# 82527

## Specification Update

*August, 2004*

Order Number: **272876-003**

**Figure 1. Bus Cycle for Mode 0 or Mode 1 Operation (Read Cycle)**

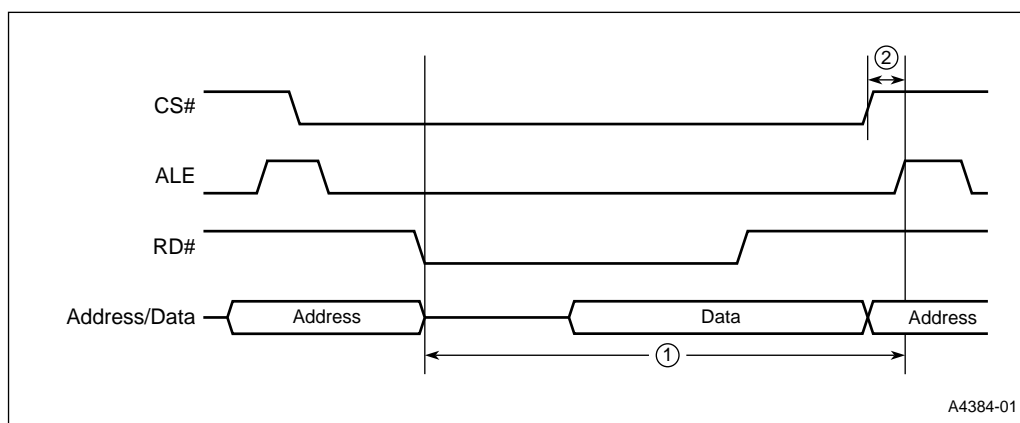
For mode 0 and mode 1 (Intel multiplexed modes), the control signals ALE, RD# and WR# are used to define the address and whether the cycle is a data read or write operation. The ALE signal is commonly used to latch the address information and generate a CS# signal to the 82527. The problem occurs in this configuration when the next cycle ALE is asserted before CS# of the current cycle becomes invalid. This circumstance presents a problem only when CS# is active and the next cycle’s ALE occurs less than  $1.5 t_{MCLK}$  after the current cycle’s RD# low. ( $t_{MCLK} = t_{OSC}/[(1 + DSC \text{ bit}) + DMC \text{ bit}]$  where DSC = Divide System Clock, DMC = Divide Memory Clock.

When performing “fast reads” associated with the double-read operation in mode 0 or 1, one of the following two conditions must be true:

1. The time from RD# low of the current cycle to the next ALE must be greater than  $1.5 t_{MCLK}$ , or
2. The CS# signal to the 82527 must be inactive before the next occurrence of an ALE, when the time from the RD# low of the current cycle to the next cycle’s CS# active is less than  $1.5 t_{MCLK}$ .

**Figure 2. Bus Cycle for Mode 2 Operation (Read Cycle)**

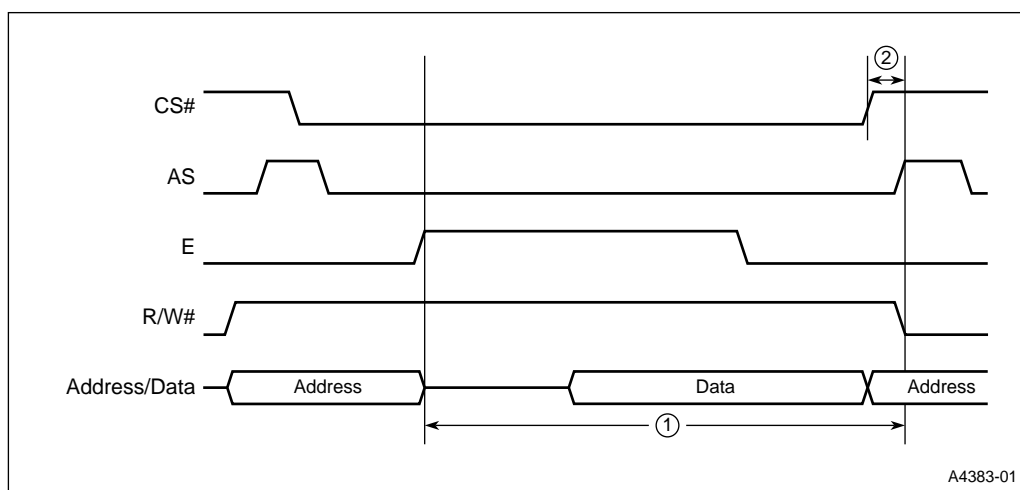
For Mode 2, the control signals AS, R/W#, and E are used to define the address, to specify whether the cycle is a data read or write operation, and to synchronize the memory accesses. The AS signal is commonly used to latch the address information and generate a CS# signal to the 82527. The problem, as outlined for Modes 0 and 1, occurs when the next cycle's AS is asserted before CS# of the current cycle becomes invalid. This circumstance presents a problem only if the next cycle's AS occurs in less than  $1.5 t_{MCLK}$  after the current cycle's E low while CS# is still active.

For Mode 2 operation, one of the following two criteria must be true:

1. The time from E high of the current cycle to the next AS must be equal to or greater than  $1.5 t_{MCLK}$ , or
2. The CS# signal to the 82527 must be inactive before the next occurrence of an AS, when the time from E high of the current cycle to the next cycle CS# active is less than  $1.5 t_{MCLK}$ .

**Figure 3. Bus Cycle for Mode 3 Synchronous Operation (Read Cycle)**

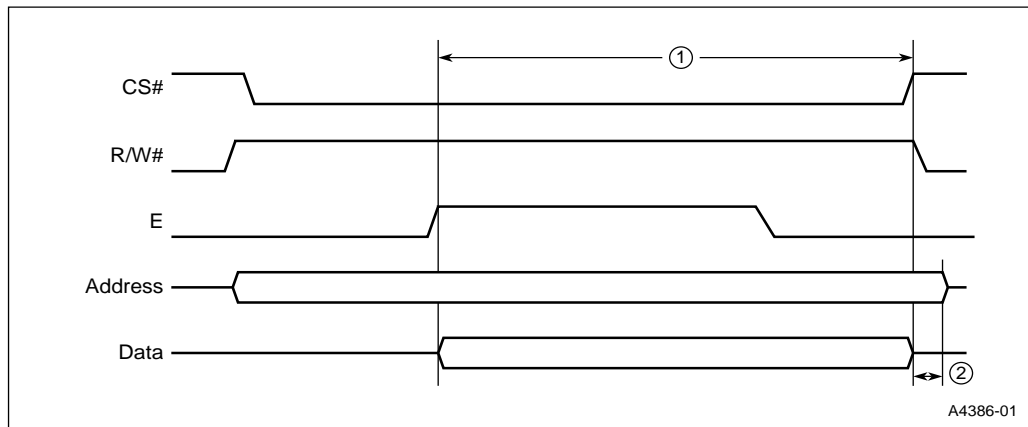
For mode 3 synchronous operation, there is no ALE or AS signal. Mode 3 is the demultiplexed mode of the 82527. For this mode, the address information must be present through the entire cycle. However, when performing fast read operations, similar considerations as the other modes must be observed to prevent problems when performing reads from the 82527.

For mode 3 synchronous operation, one of the following two criteria must be true:

1. The time from E high of the current cycle to CS# invalid must be equal to or greater than  $1.5 t_{MCLK}$ , or
2. Address information must remain valid on the bus until after CS# goes inactive.

**Figure 4. Bus Cycle for Mode 3 Asynchronous Operation (Read Cycle)**

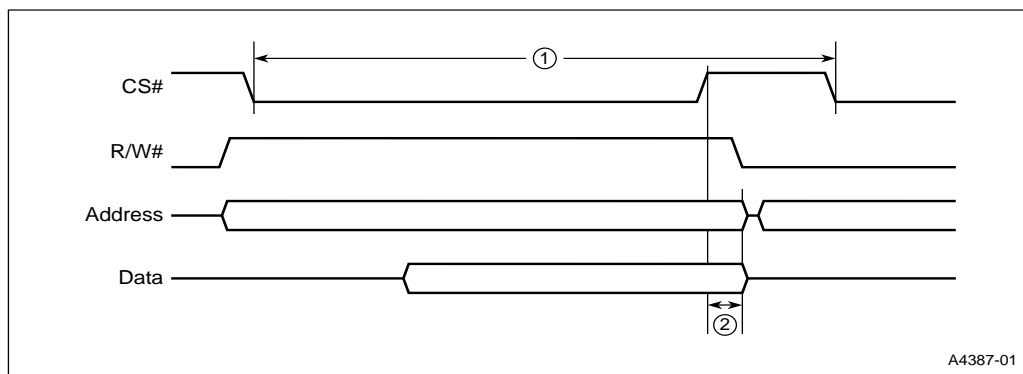
Mode 3 asynchronous is also a demultiplexed mode of operation on the 82527. This mode is typically used with the DSACK0# signal. When using mode 3 asynchronous with host CPUs that do not have the DSACK0# input, the following considerations must be observed to prevent problems when performing reads of the 82527.

For Mode 3 asynchronous (no DSACK0#), both of the following criteria must be true:

1. The time between consecutive CS# cycles must be equal to or greater than  $2 t_{MCLK}$ .
2. Address information must remain present on the bus until after CS# goes inactive.
